Addendum 2

The contractor shall upgrade interior finishes as detailed in this addendum using any applicable details in the construction drawings and specifications to complete the work. Refer to original documents for exterior finishes. Contractor shall build out between gridlines 8-12, A-G as shown on the on the following pages to construct rooms 201,202, 204, 205, 206, 207 & 200 where open space was shown on original referenced pages. This new work also includes the associated mechanical and electrical required for a functional office space. No reduction of work otherwise included on these referenced sheets or elsewhere in the contract documents shall be implied by this Addendum.

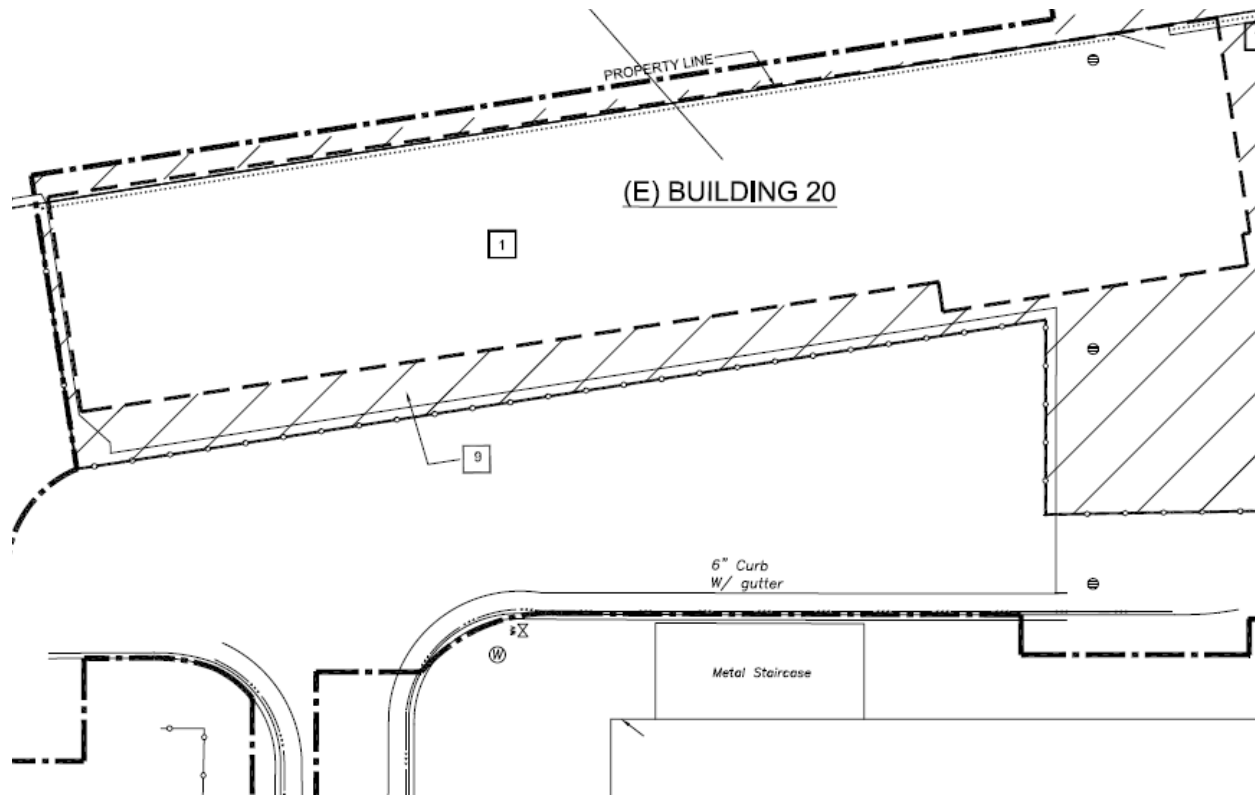
Contractor is responsible for demolition and removal of all of building 20 to include disconnection of electrical utility to the building. Area of work and temporary construction fence shall encompass building 20 and work shall comply with specifications. Contractor shall compact site to be flat and graded with gravel to be flush with existing asphalt. Provide new 6' high chain link fence per detail G/C-8.0 No reduction of work otherwise included on these referenced sheets or elsewhere in the contract documents shall be implied by this Addendum.

Mechanical

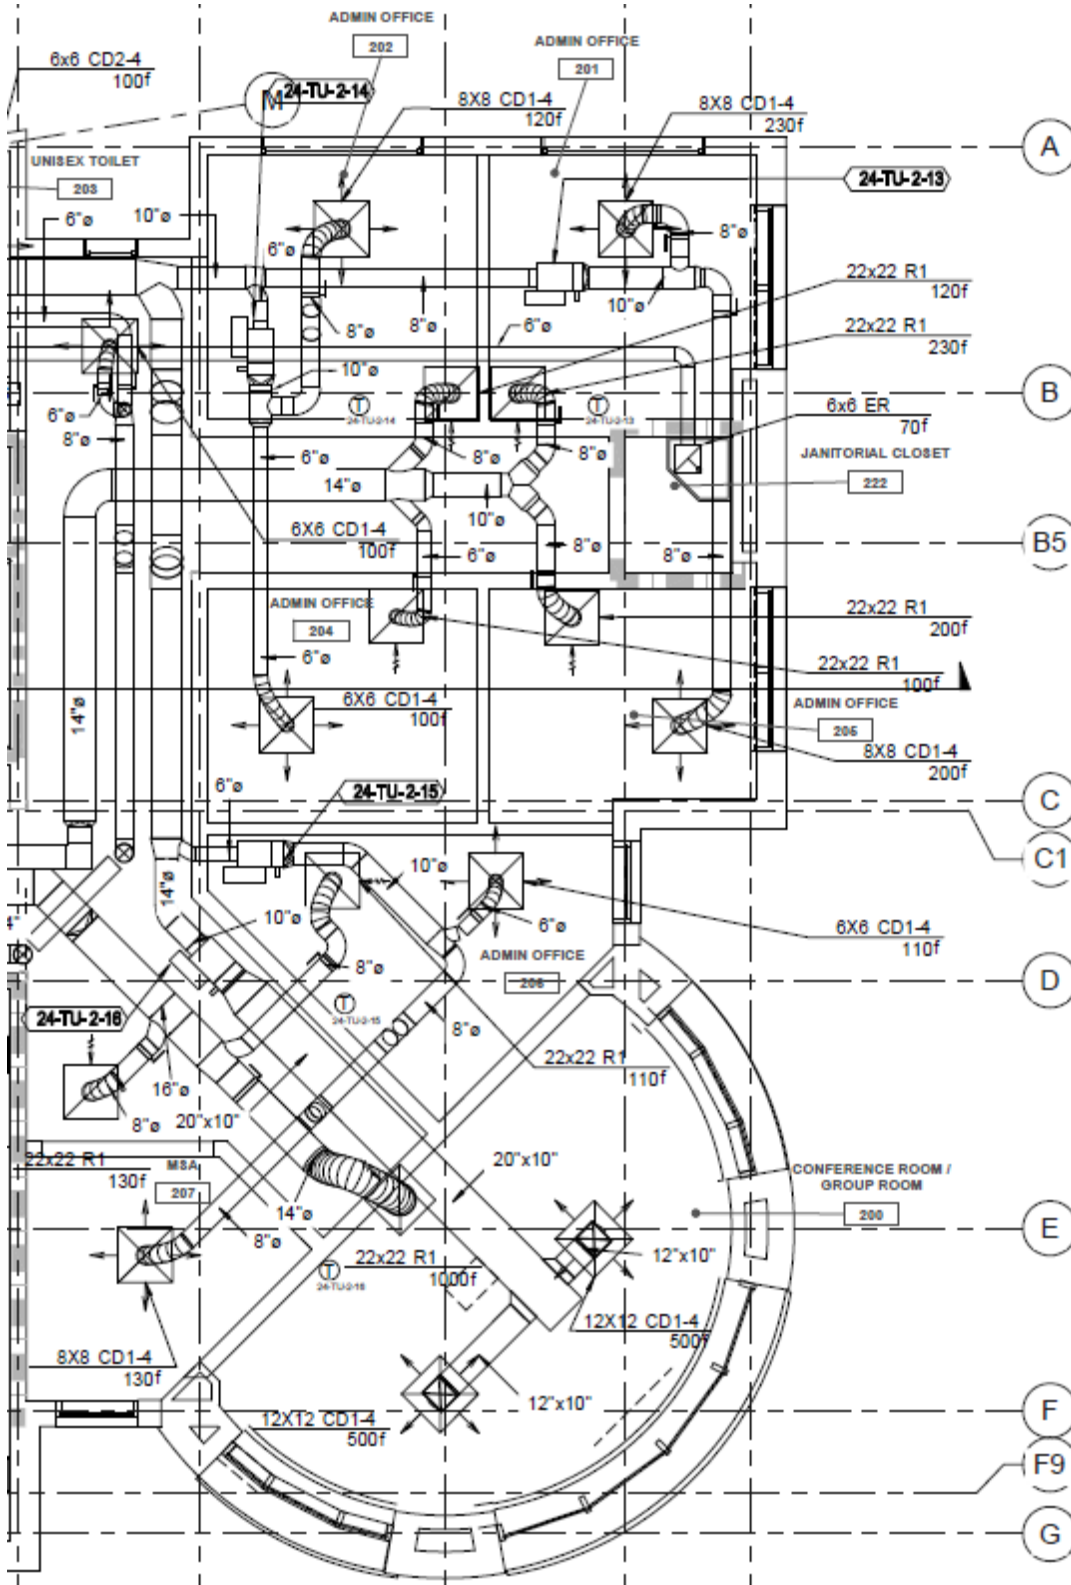
TU 3-15	TITUS	3RD FLOOR	301, 302	AHU-1	6	240	[110]	120	[57]	NONE	VAV	6.8	0.4	2	YES
---------	-------	-----------	----------	-------	---	-----	-------	-----	------	------	-----	-----	-----	---	-----
